PROCLAMATION CALLING A SPECIAL MEETING OF THE BERKELEY CITY COUNCIL

**1. ZAB Appeal: 2720 Hillegass Avenue, Willard Park, Use Permit/Variance
#ZP2022-0095**

To: Honorable Mayor and Members of the City Council
From: Dee Williams-Ridley, City Manager
Submitted by: Jordan Klein, Director, Planning & Development Department
Subject: ZAB Appeal: 2720 Hillegass Avenue, Willard Park, Use Permit/Variance #ZP2022-0095

Figure 4: Community Center Floor Plan

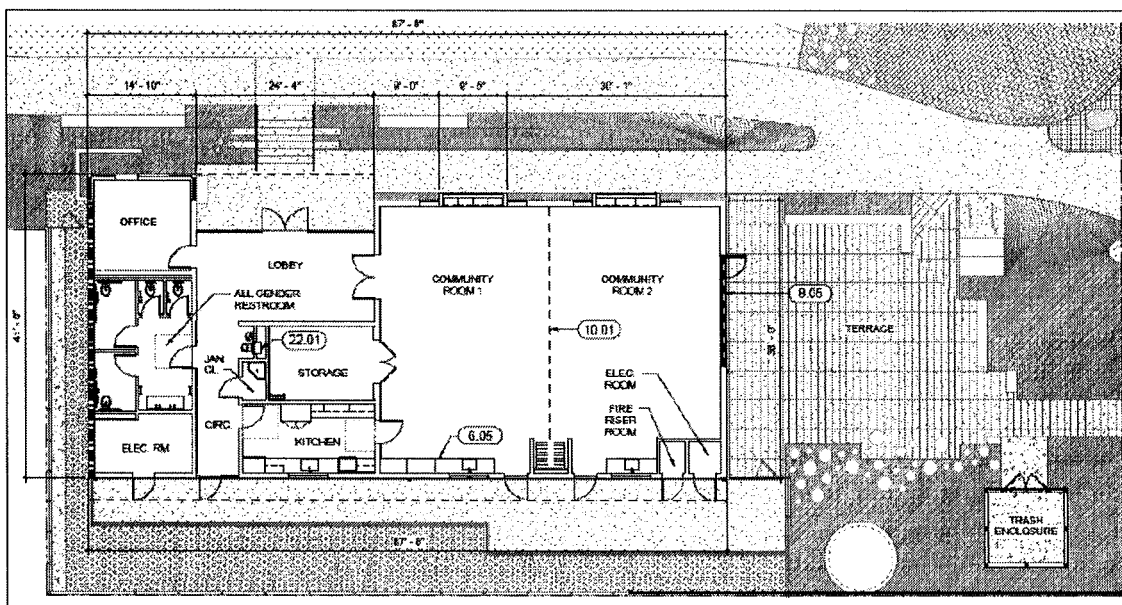
To calculate the real loss of usable open space, you must start with the size of the new Community Center building (external footprint: 3,500 sf), add in the open space that will be fenced off behind and beside the building that will no longer be accessible except for those using the Community Center (1,600 sf), due to the fence and gates around the new building – see the greyed out portions on the West and South sides of the building, and finally add in the area for the new restroom (216 sf), then subtract the size of the old building 679 sf (external footprint) and the area in the SE corner of the park that will no longer be fenced in. This yields roughly 4,636 sf of open space that will no longer be part of the park. (See *Attachment 1: Greenfire Law letter to ZAB, page 3 item 3 Open Space Reduction.*)

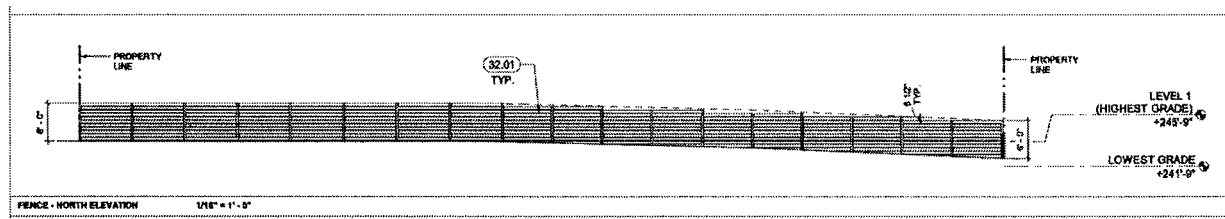
The proposed Community Center building has been described as a single-story structure and its average height has been declared as 18 ft. While this is true, it is also misleading. The highest point is 20 ft off the ground (see the drawing below: T.O.ROOF-N – LOWEST GRADE, i.e., 261'-5 1/2" – 241'-9") and is larger than the height of the two-story building located in the back of 2732 Hillegass – see (E) Residence shown on the drawing below.

Please note that the current single-story clubhouse, which has the height of 12 ft, is much shorter and is closer to Hillegass, thus the park view from residence (E) is unobstructed. (Sheet Z2-A1)

View Impact – 2731 Regent

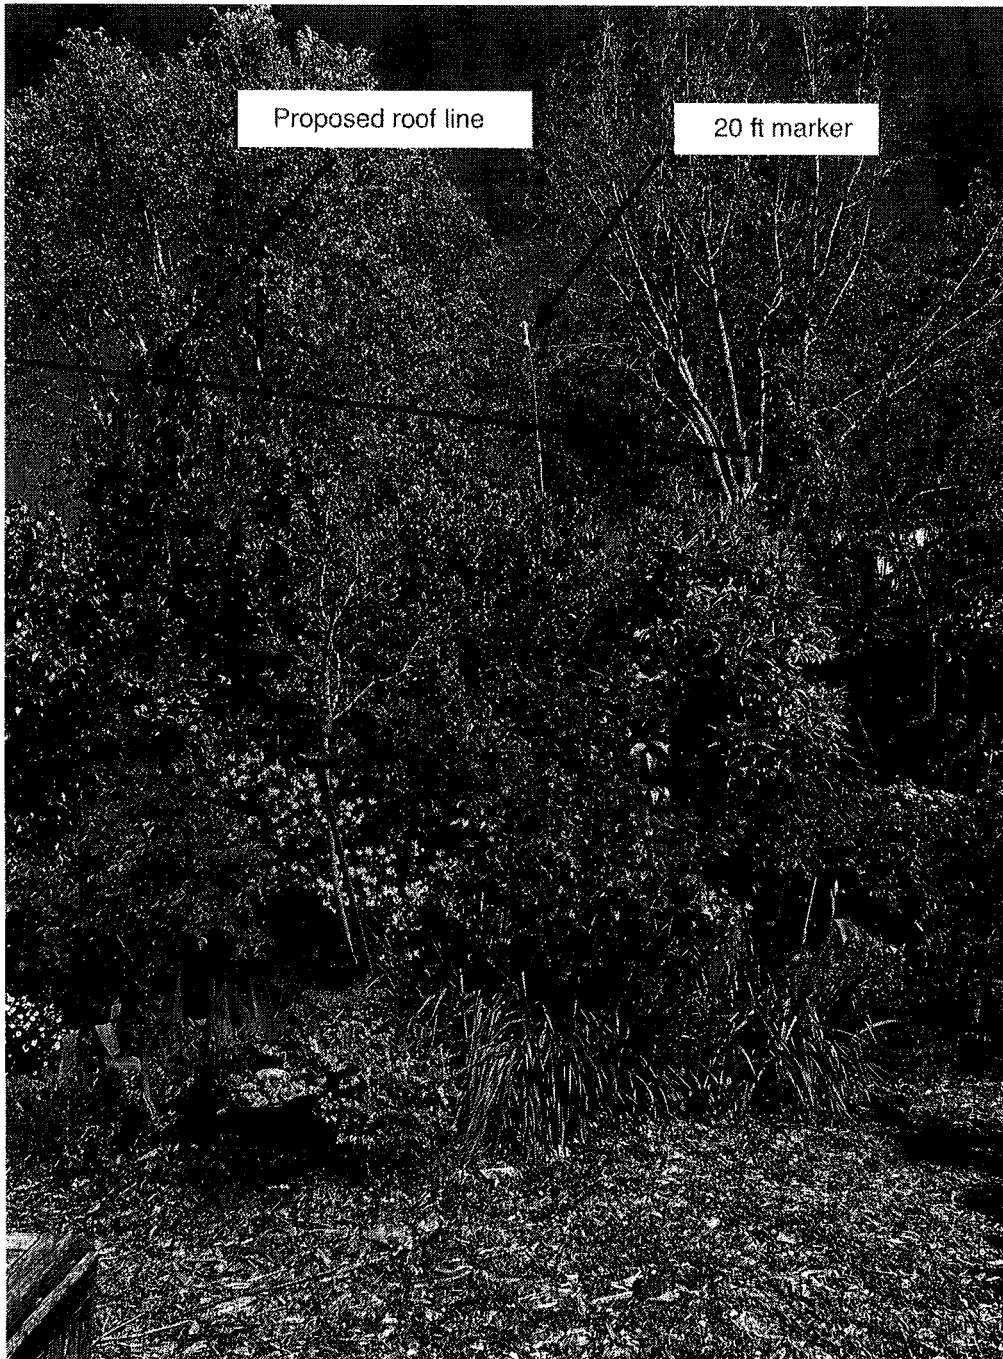
The new building will be towering over the backyard of the 2731 Regent St lot. See photos below.

Response 6: The proposed building is one story in height and no significant view corridors would be affected by the ZAB-approved project.

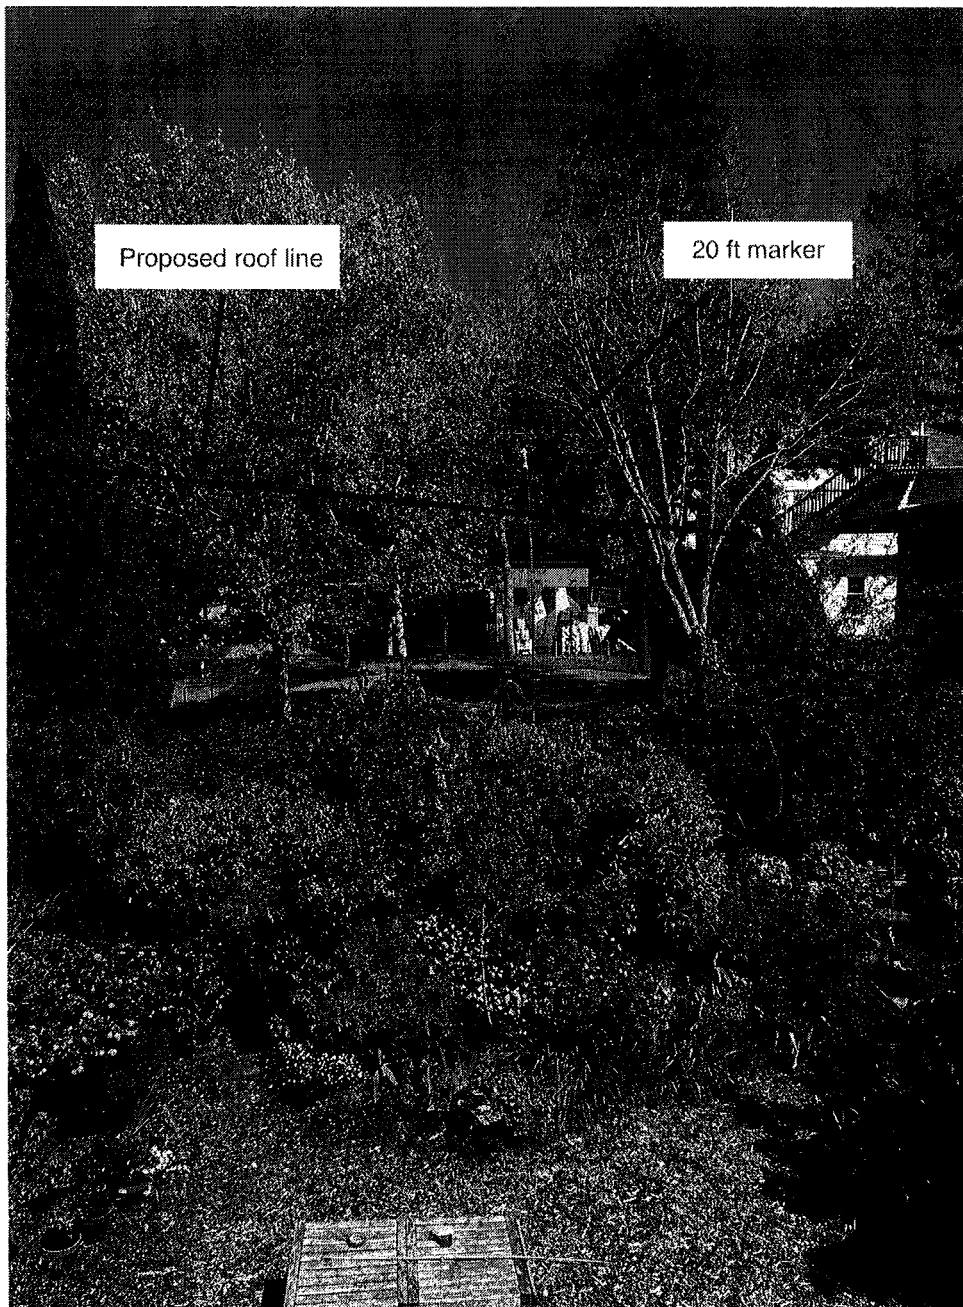
In contrast the photo below shows the view from the second floor of the home at 2731 Regent St with the same 20 ft marker, and the proposed roof line.

The existing clubhouse and the plaza are in the background. Please note that the maximum height of the new, one-story building in the picture is almost equal to the height of the existing, two-story building on the right. (2732 Hillegass Ave.)
